City of Portland, Oregon
Bureau of Development Services
Land Use Services

NOTICE OF A TYPE II DECISION ON A PROPOSAL IN YOUR NEIGHBORHOOD

CASE FILE NUMBER: LU 14-116944 AD – ADU DESIGN STANDARDS

Site Address: 2525 SE 22ND AVE

west elevation

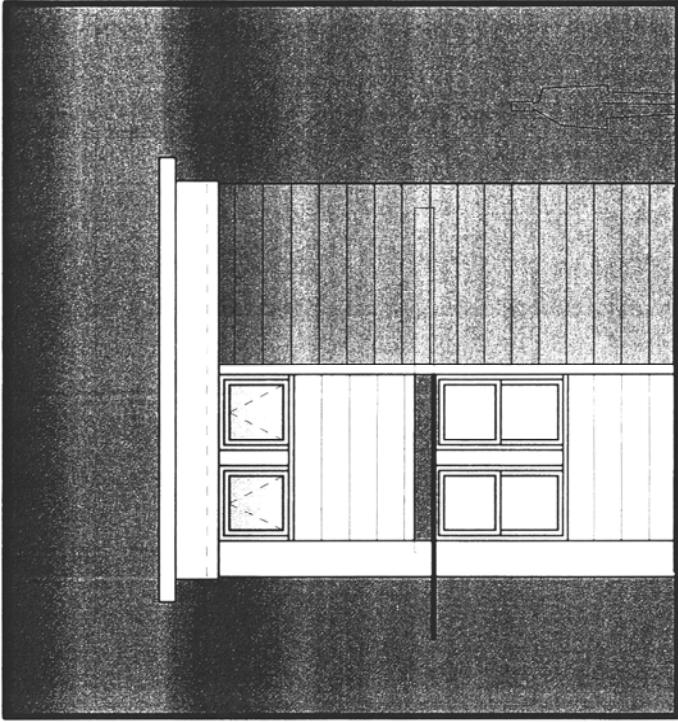
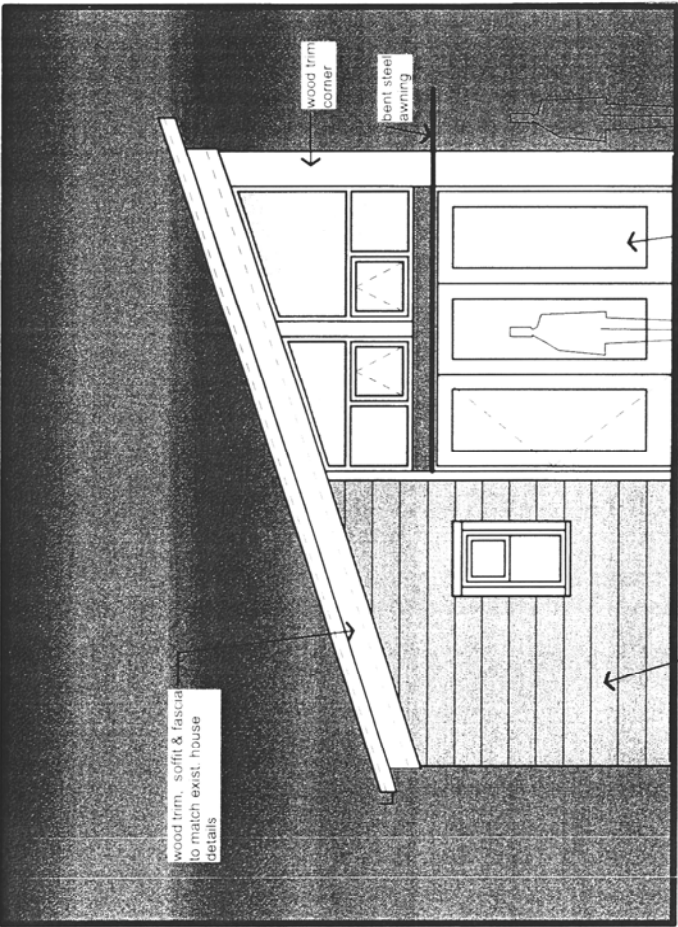
Adjustment 2, Window Proportion: The slanted windows proposed for the west side of the ADU are invisible from any other property, being on the side that faces away from the street and adjacent to a mature tree in the southwest corner of the yard. The slanted windows work within the context of the design as they follow the line of the shed roof. The shed roof is allowed on ADUs, and the windows are responding to that context. Further, the windows on the primary house are of many different proportions and do not provide a unified pattern to follow. Given their invisibility from any vantage point, these windows do not make the ADU incompatible with this changing neighborhood.

Adjustment 2, Window Proportion: As discussed in A, the proposed windows that do not meet the proportions of any windows on the primary house are not visible from other sites and therefore do not impact livability or appearance. However, they do benefit the proposed ADU by maximizing natural light in the small living unit, while providing views to a mature backyard tree. All other proposed windows do

Approval of two Adjustments to the Zoning Code, Sections 33.205.030.C.8 and 33.205.030.C.10, to construct an ADU with a roof pitch of 4:12 and include two sets of windows in the west façade that are angled, following the roof pitch, per the approved site plans, Exhibits C.1 through C.4, signed and dated March 25, 2014, subject to the following conditions:

a3.1

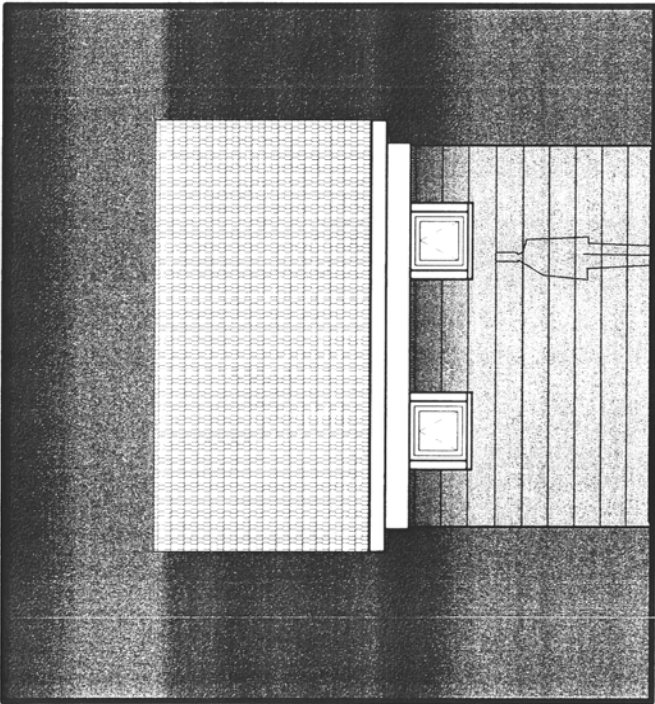
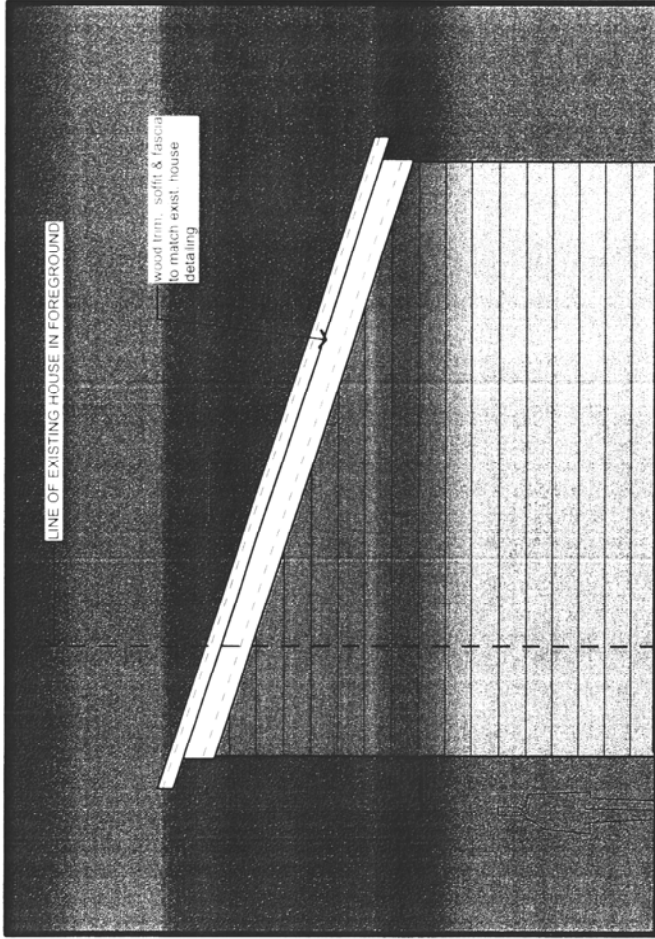
Adjustment 1, Roof Pitch: The shed roof style is not at issue, but rather the pitch of the shed roof, which is 4:12 rather than 8:12 to match that of the hipped roof of the house. The applicant makes the point that there are several other roof pitches on the site: the porch roof and the south side bay window each have a 3:12 slope while the adjacent detached garage has a 12:12 slope. Given the diversity in roof types and pitches, and the desire to maintain a view from the primary house’s master bedroom to the tree in the backyard, an 8:12 roof pitch on the shed roof would not necessarily be more compatible with the site or the nearby residential area. Matching the pitch would in fact make a more imposing, taller and more extreme structure given the shed roof style.

Adjustment 1, Roof Pitch: The style of the roof is a shed roof, which rises up to a high point on one side (enabling the addition of a storage loft in the ADU). Requiring the ADU's roof pitch to match the pitch of the primary house would result in a steeper roof, a taller structure and a starker contrast to the surrounding development. It would also reduce the amount of usable space within the ADU because the steep roof pitch and the ADU height limit would combine to lower the roof line in the lower part of the structure. The proposed 4:12 pitch closely matches the 3:12 pitch on the primary house's front porch and south side bay window. Visibility is limited because of the existing tree in the right-of-way. This well-designed ADU will not significantly impact the livability or appearance of this residential area.
